**TITLE**: **SPECIAL PERMIT NO. 459A,** an amendment to the **Georgetown Apartments Community Unit Plan,** requested by Olderbak Georgetown/Willows, LLC, on property generally located at South 70th Street and Van Dorn Street.

**LINCOLN/LANCASTER COUNTY PLANNING STAFF REPORT**

**PROJECT #:** Special Permit No. 459A - Georgetown Apartments

**PROPOSAL:** Amend the Community Unit Plan (CUP) to increase the allowed density from 115 units to 160.

SHEET
C-1.1

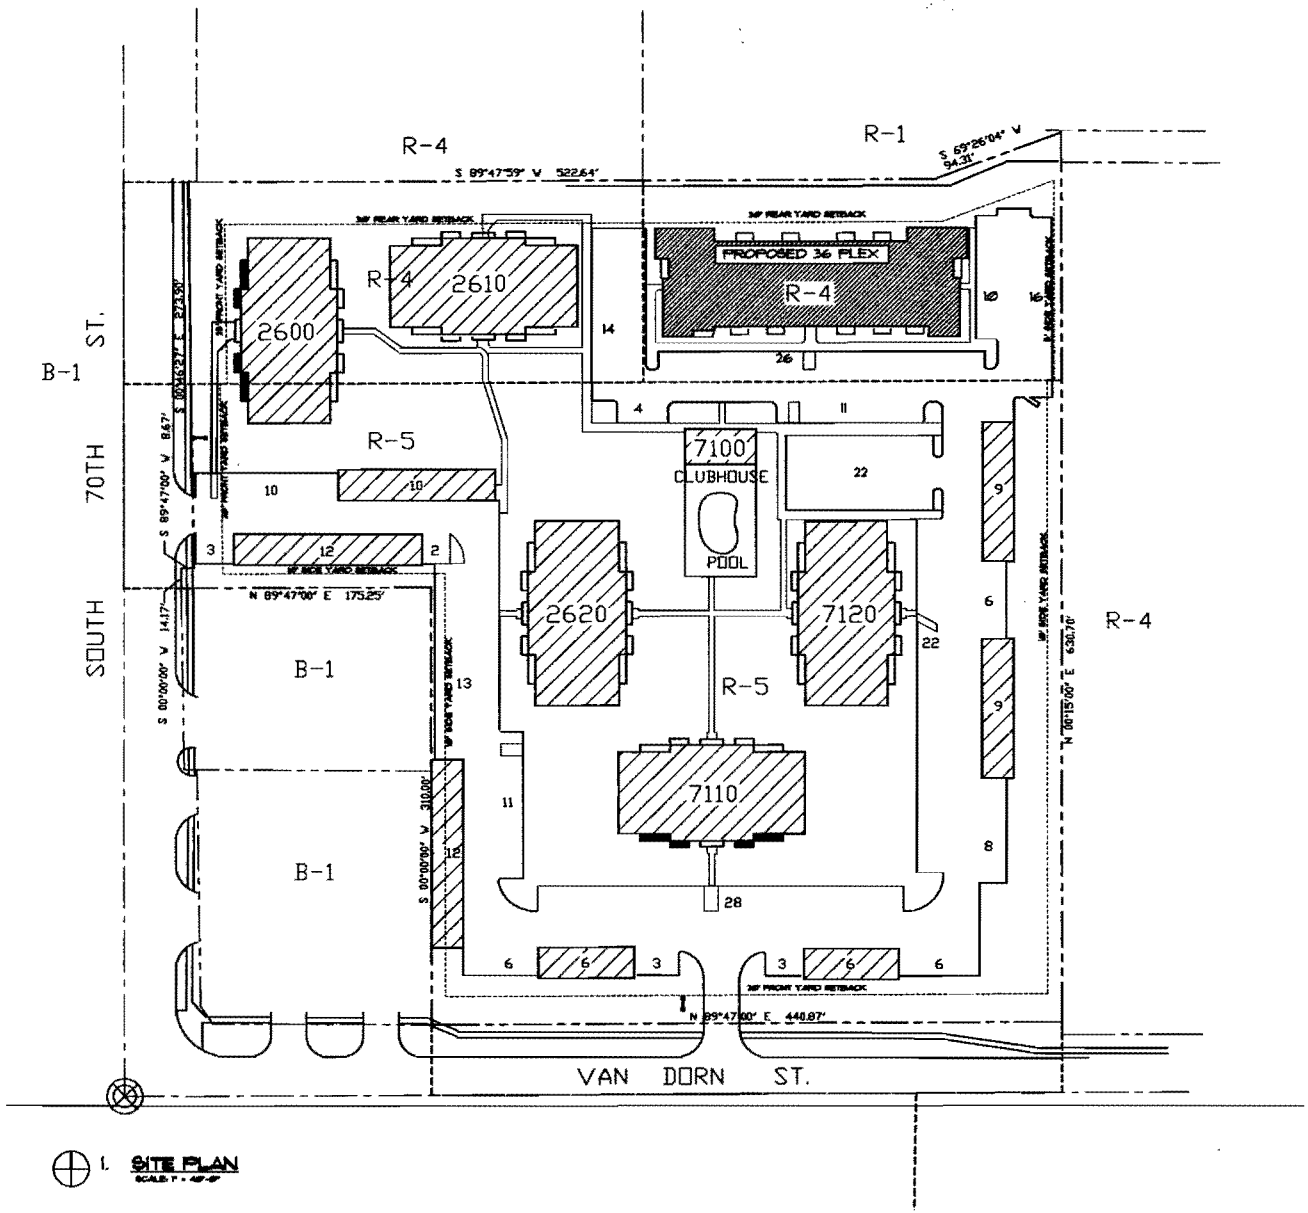
5. The parking calculation on the proposed site plan shows that 285 off-street parking stalls are required, with 288 being provided. That calculation is correct when applying the R-4 (two spaces per dwelling unit) and R-5 (1.75 spaces per dwelling unit) parking standards to the respectively-zoned areas within the CUP. However, Section 27.67.065 of the parking ordinance has an additional requirement that holds CUP's to a higher standard and requires two spaces per dwelling unit, regardless of zoning. Applied to this request, an additional 14 spaces need to be provided for a total of 302 spaces.

The waiver now being requested seeks to adjust the number of required stalls from 302 to 288. The applicant notes that in part the waiver is needed to address concerns voiced by the neighbors. They asked that the parking area on the east side of the building be removed so the area could be left as open space. They also asked that the parking on the west side be pulled back to the extent it could be to also preserve some open space and provide additional separation between cars and homes on the west as well.

This request approves a revised site plan showing 151 dwelling units with 9 unallocated units for a maximum of 160 units with a waiver to adjust the required parking from 302 to 288 stalls.

'EXHIBIT A'

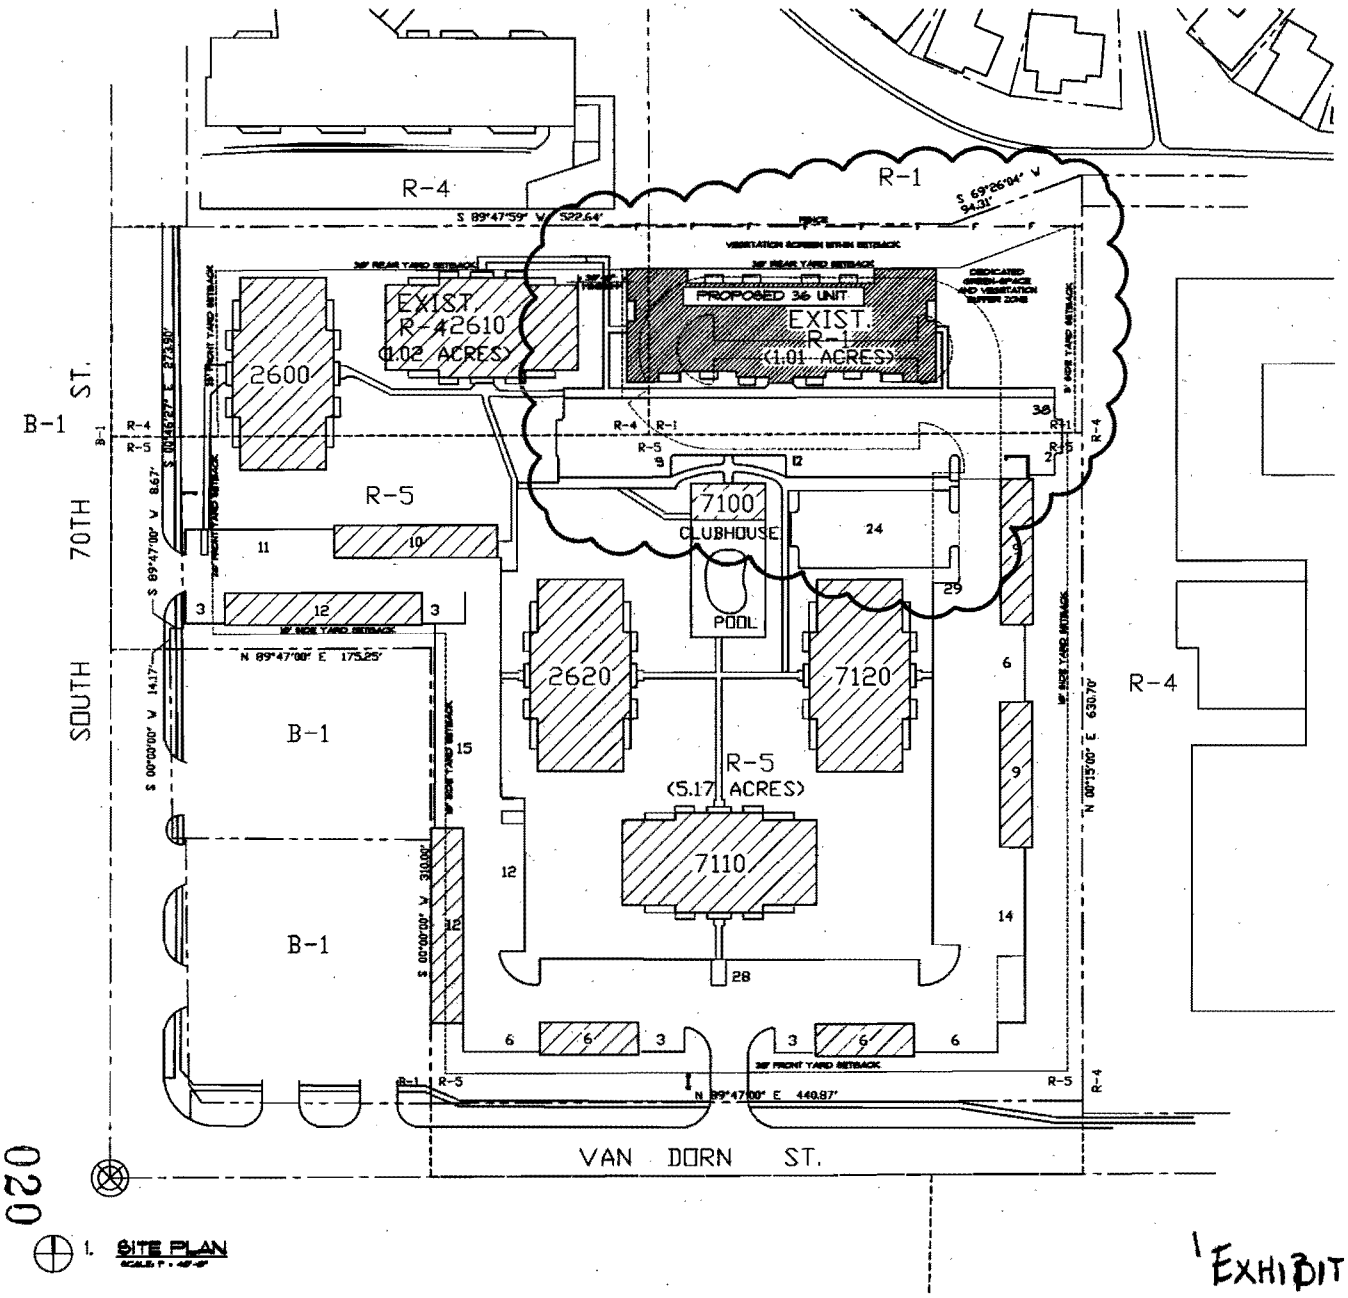
1. We ask for a waiver to adjust the required parking from 302 to 288 stalls. The neighboring residents strongly expressed their concerns of having the parking lots near the North property line creating visual and audio disturbances. To prevent this, we have removed the parking lots on the Eastern and Western sides of the proposed building, which prevents us from being able to meet the 302 required parking stalls. Please refer to item 5 of the Planning Staff report for further explanation of this request.
2. In cooperation with the adjacent Neighborhood Association, we are asking to include items 1.2.2, 1.2.3, 1.2.4, and 1.2.5 to the 'Site Specific Conditions' set forth in the Planning Staff Report. Please see attached sheet and Exhibit.

REVISIONS DATE
09-8-2
1) EXISTING R-1 ZONE AREA TO REMAIN R-1 DENSITY TABLE REVISED TO REFLECT CHANGES.
2) PARKING WAIVER REQUESTED TO REDUCE TOTAL BY 14 STALLS.

1.2.2 Per Exhibit A for the new 36-unit apartment building in the northeast corner of the site, reflect the placement of the building, adjacent parking, surrounding landscaping and placement of trees and accompanying vegetation. Identify all plant material and provide all typical landscape plan information.

1.2.3 That the land directly to the east of the new apartment building will be landscaped and maintained as a green space with grass, trees and other vegetation forming a buffer zone between the Georgetown Apartments and the property to the north.

1.2.4 That an opaque 6 foot privacy fence will be built generally along the north boundary of the special permit.

1.2.5 That the 30 foot setback between the new building and the property to the north will be planted with additional trees and other appropriate vegetation beyond the minimum design standards, to create at least a 75% screen between 6 and 15 feet above the adjacent ground elevation between the new apartment building and the homes to the north.
